Urgent Field Safety Notice

SBN-RDS-CoreLab-2021-003

Iron Gen.2: throughput dependent signal drifts on cobas c 311, cobas c 501/502 and COBAS INTEGRA® 400 plus

1.1.1. cobas c 311/501:

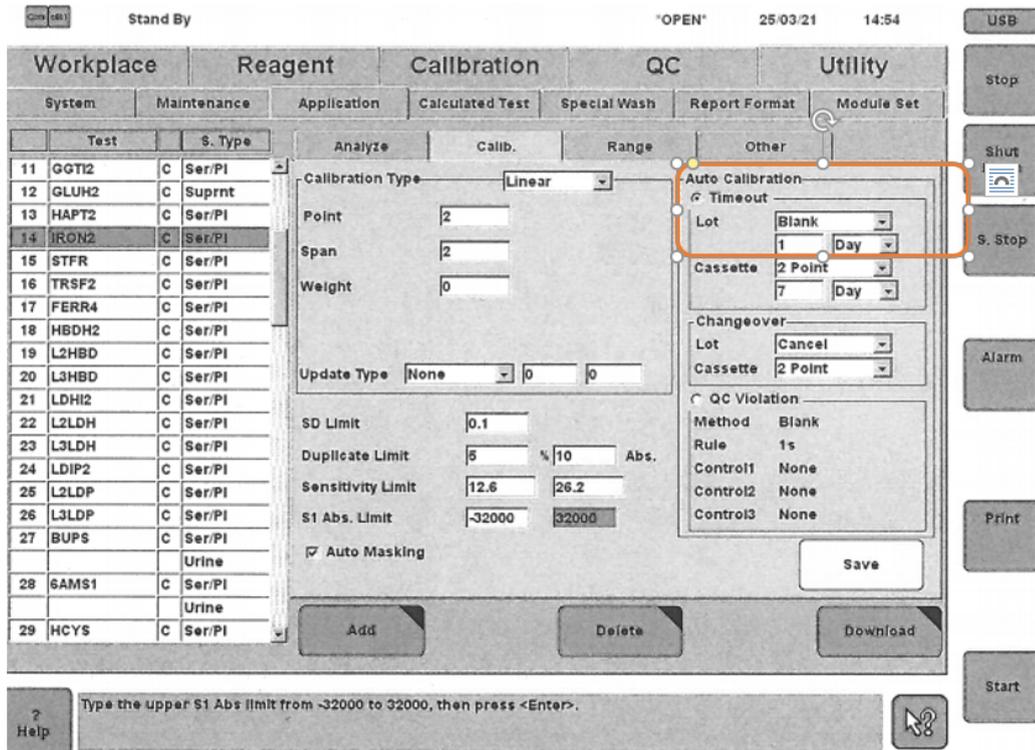
Modules running < 50 IRON2 determinations per day out of one **cobas c** pack need to perform a blank calibration with the zero calibrator using deionized water, which can be set on the analyzer by changing the lot calibration "Timeout" to "blank" and a "timeout" to "1 day" as follows:

Utility >> Application >> Calib. >> Auto Calibration >> Lot Blank 1 Day >> Save

1.1.3. COBAS INTEGRA® 400 plus analyzer

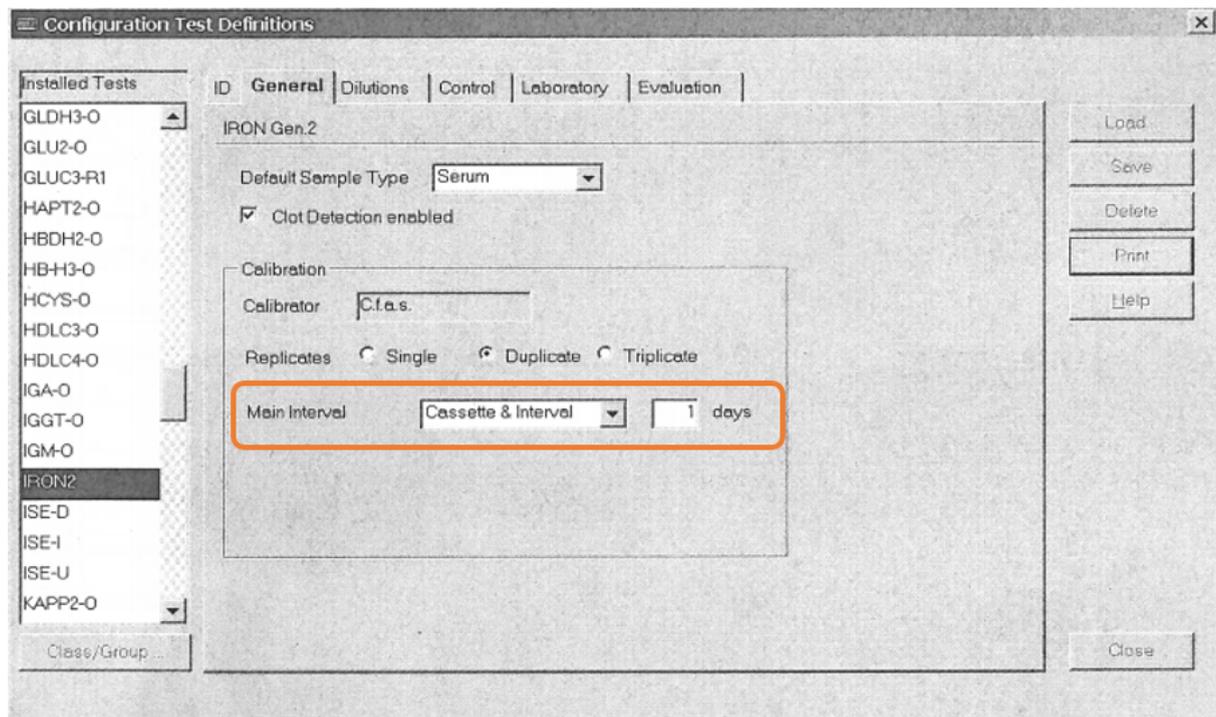
COBAS Integra® 400 plus modules running < 50 IRON2 determinations per day need to perform a full calibration with timeout “1 day”.

Configuration >> Double click Tests in the Definition group >> Select the required test from the installed tests list >> Select the chapter “General” >> Select calibration >> Select Main interval >> Choose C cassette & Interval >> Enter “1” in the corresponding text box “Days” to define the period to repeatedly define the calibration

2.1.1. cobas c 311/501:

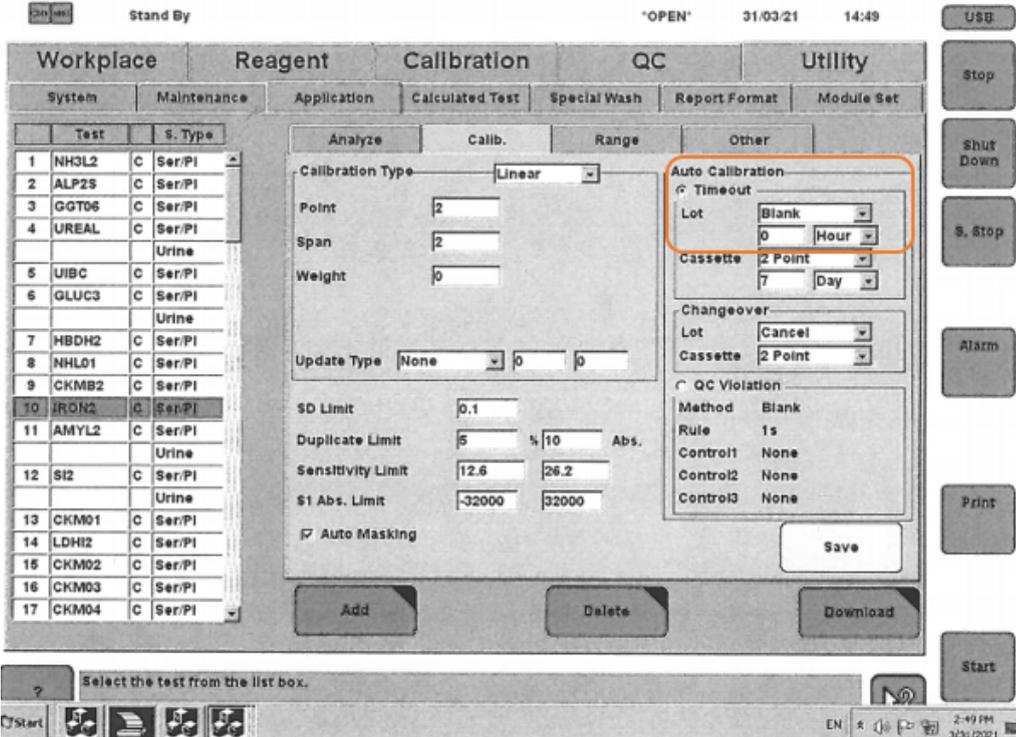
Modules running ≥ 50 IRON2 determinations per day need to

- o Perform a blank calibration manually at least after every 50 IRON2 determinations with the zero calibrator using deionized water OR
- o Adjust the timeout calibration according to the lab specific estimation of IRON2 determinations depending on the throughput in the laboratory e.g. to 1 hour, 2 hours, etc.

Application >> Calib. >> Auto Calibration >> Lot Blank "xx" hours >> Save

2.1.2. cobas c 502:

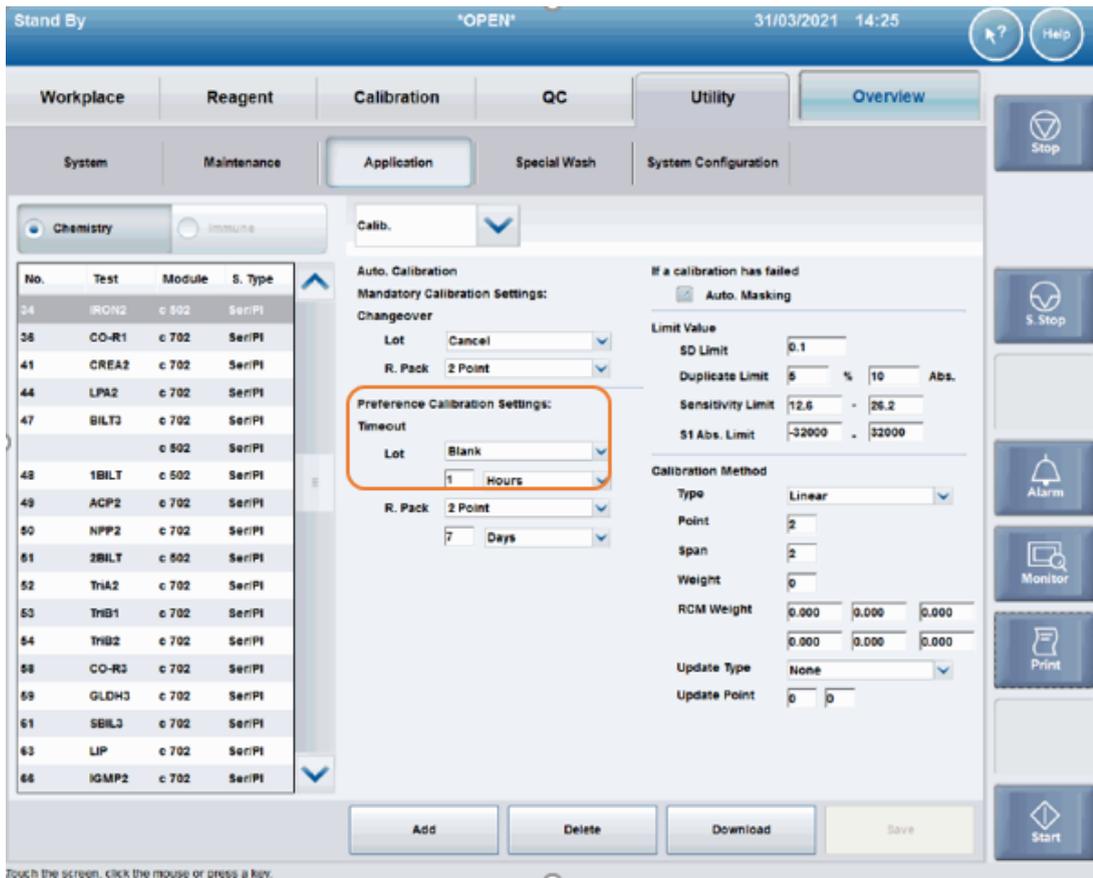
The specification of the time interval must be defined by the customer according to the individual assessment. It must be ensured that no more than 50 IRON2 determinations per calibration interval are measured within the specified time interval.

Utility >> Application >> Calib. >> Preference Calibration Settings >> Lot Blank “xx” Hours >> Save
